Re: PA0358 & PA0364; Dawson, Fayette County, Pennsylvania; Signal upgrades at the River Rd. and Laughlin St. grade crossing with CSXT; 145463A & 145459K; Central Zone, Pittsburgh Subdivision; BF-275.25 & BF-275.87 Docket No. A-2019-3011890

Subject: A-2019-3011890; PA0358 & PA0364; Dawson, Fayette County, Pennsylvania; Signal upgrades at the River Rd. and Laughlin St. grade crossings with CSXT; 145463A & 145459K; Central Zone, Pittsburgh Subdivision; BF-276.25 & BF-275.87
Responses to PUC Plan Review Letter

Reference is made to the Pennsylvania Public Utility Commission (PAPUC) letter dated June 26, 2023 transmitting the PAPUC's review comments on the situation and circuitry plans for the subject project. On behalf of CSXT, Bergmann provides the following responses in **bold text**:

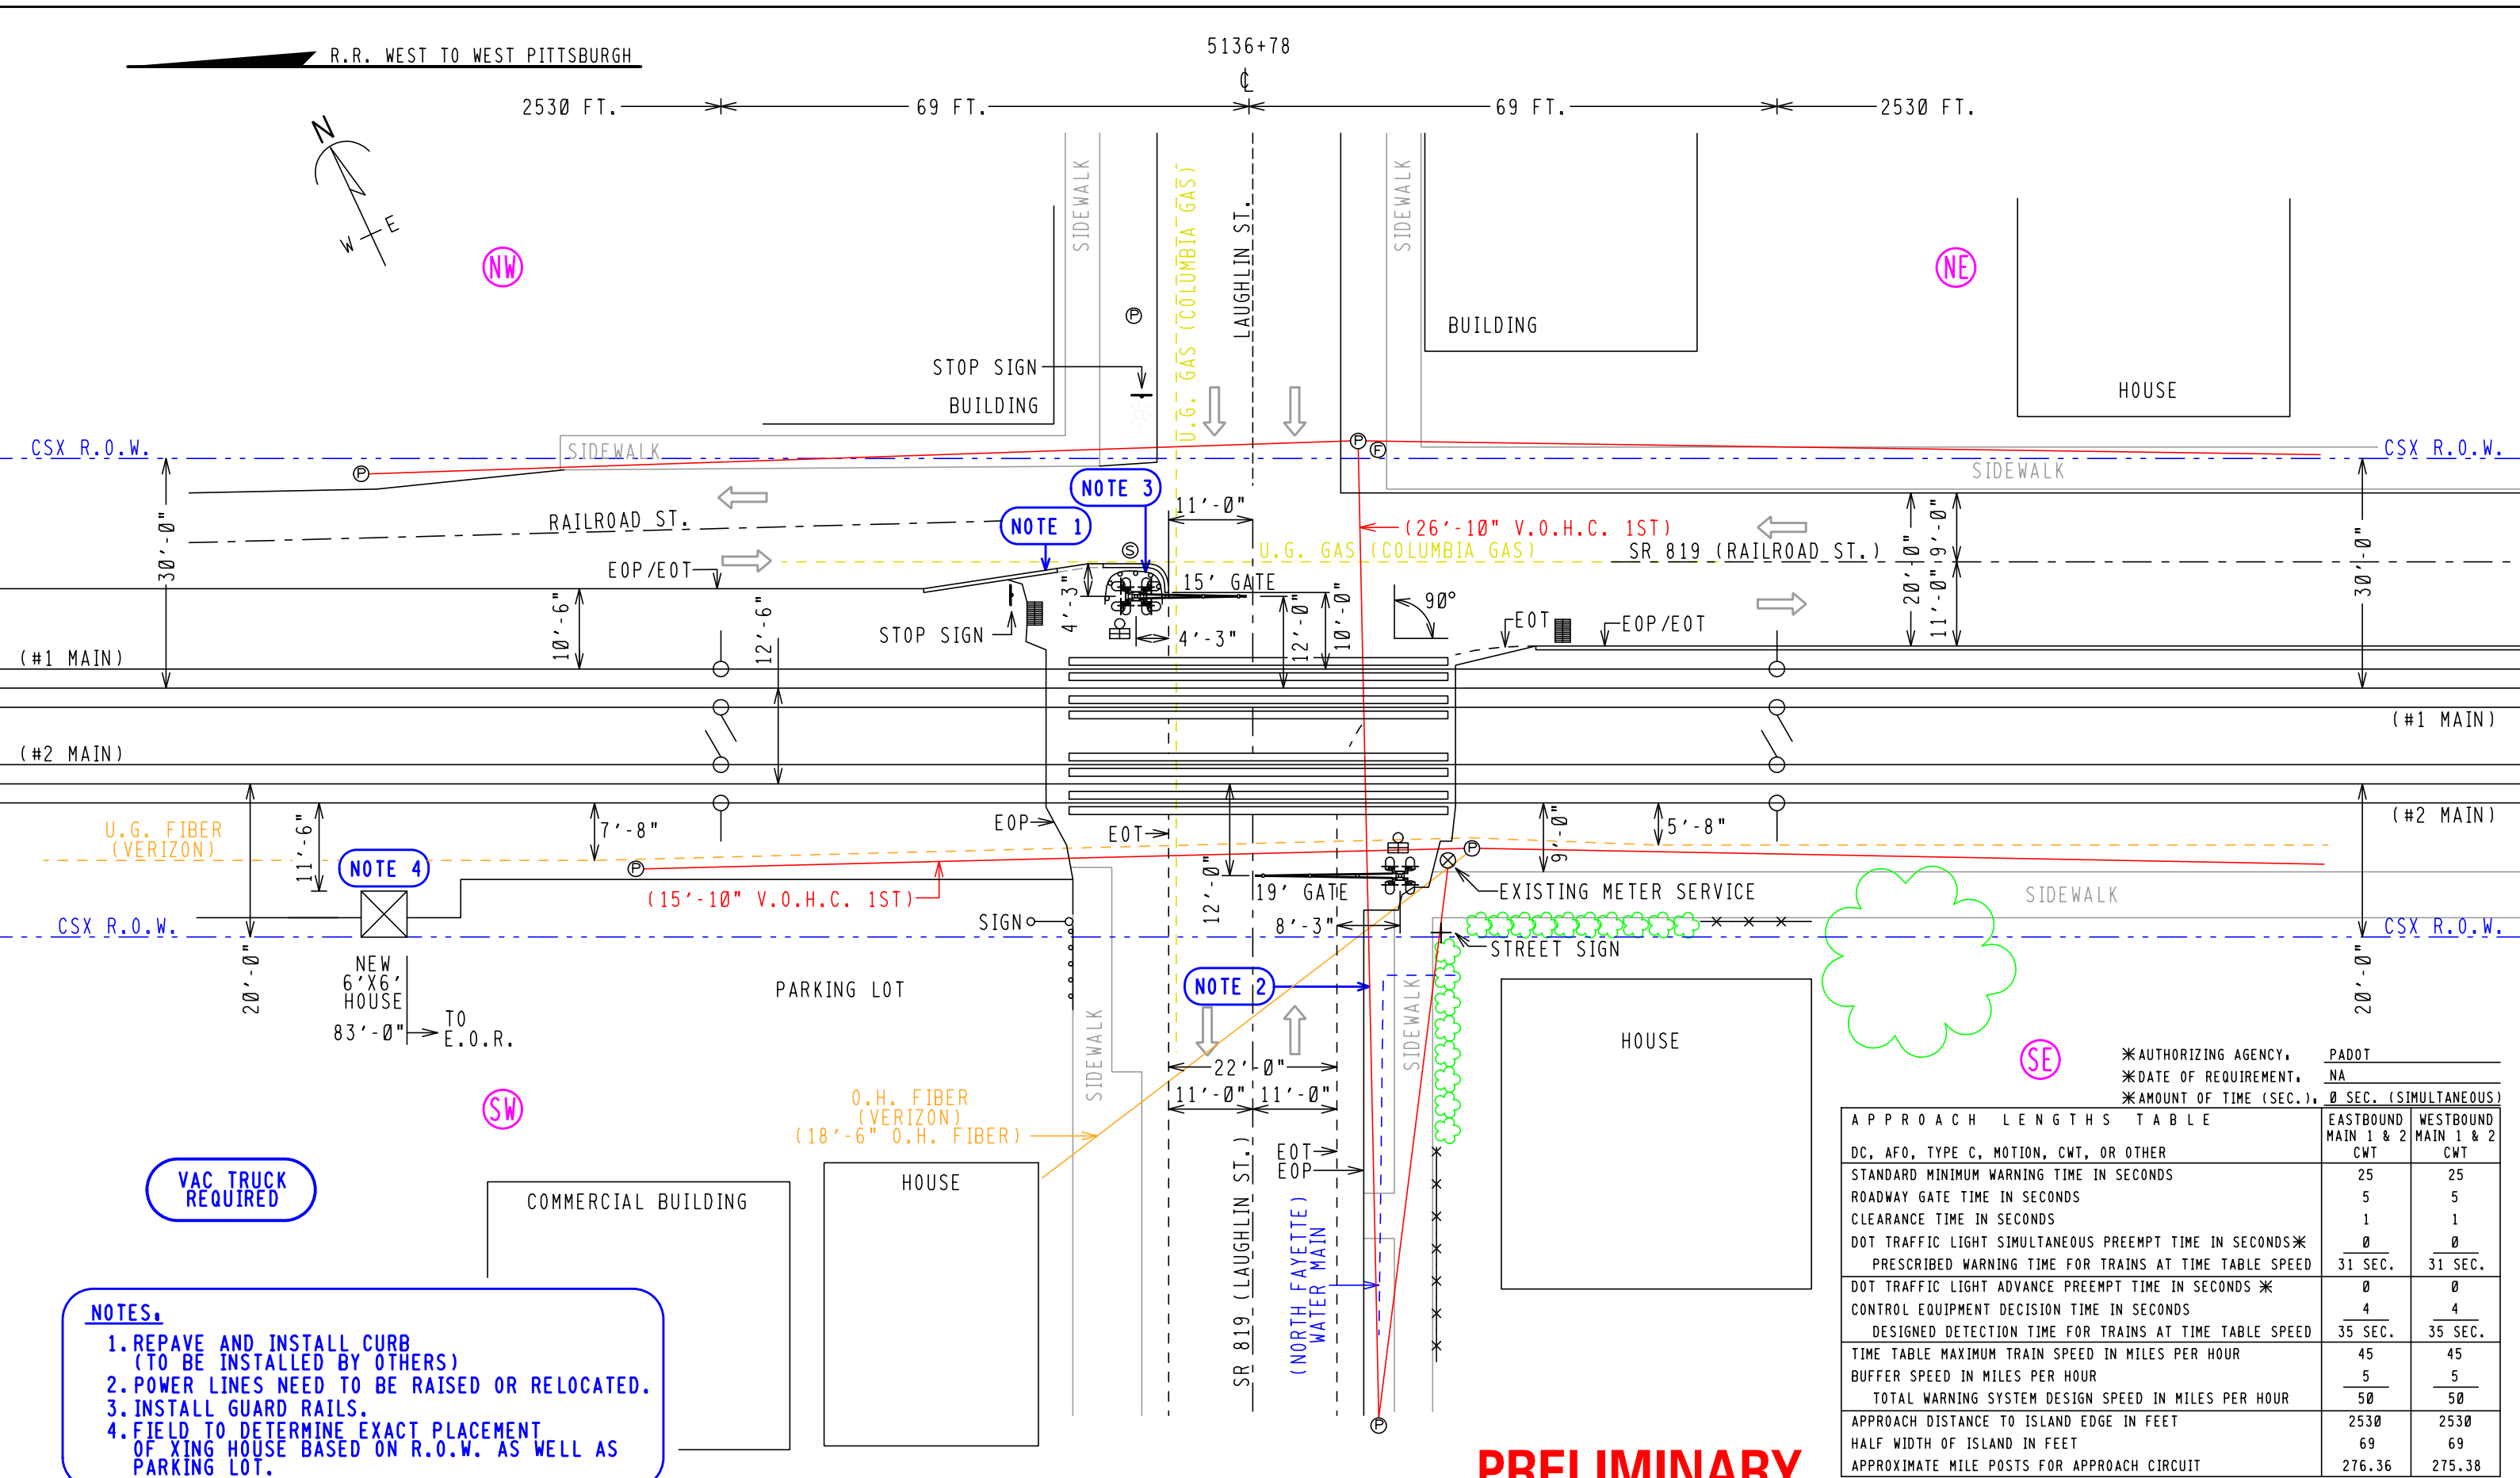
2. The 6' x 6' signal house is shown half inside the Right-of-Way (ROW) line for CSX and half over the ROW line. Has the railroad obtained an easement or acquired property to locate the cabinet outside of CSX ROW?

3. The situation plan for the State Route 0819 (DOT 145 459 K) (Laughlin Street) crossing on sheets #5 and #46, show guiderail being placed around the warning devices in the northwest quadrant and around the signal cabinet/house in the southwest quadrant. This use of guiderail was not approved and memorialized in the Secretarial Letter dated August 3, 2022. In order for the guiderail to be placed, the Commission will need to memorialize the installation and maintenance of the guiderail in a Secretarial Letter.
 - a. Has Pennsylvania Department of Transportation agreed on the location and placement of guiderail along State Route 0819?

- b. Has the property owner and Dawson Borough agreed on the location and placement of guiderail around the signal house?

- 4. Note 1 on the situation plan on sheets #5 and #46 states "REPAVE AND INSTALL CURB (TO BE INSTALLED BY OTHERS)". This installation of curbing was not assigned and memorialized in the Secretarial Letter dated August 3, 2022. In order for the curbing to be placed, the Commission will need to memorialize the installation and maintenance of the guiderail in a Secretarial Letter. Which party is going to be responsible to pay to install the new curbing? Also, which party has agreed to be responsible to maintain the curbing?

The location of the proposed signal house at the Laughlin Street crossing has been revised so it is located entirely on CSXT's right-of-way.

Per the November 09, 2023 e-mail from Tom Ryczek, PennDOT is agreeable to the placement of the guiderail.

Per response to Comment 2, the location of the proposed signal house at the Laughlin Street crossing has been revised so it is located entirely on CSXT's right-of-way.

CSXT is to install the guiderail. Per the November 09, 2023 e-mail from Tom Ryczek, PennDOT is agreeable to paying for its installation.

CSXT is to install the new curbing. Per the November 09, 2023 e-mail from Tom Ryczek, PennDOT is agreeable to paying for its installation. Per your December 26, 2023 e-mail, maintenance is to be assigned at a later date.
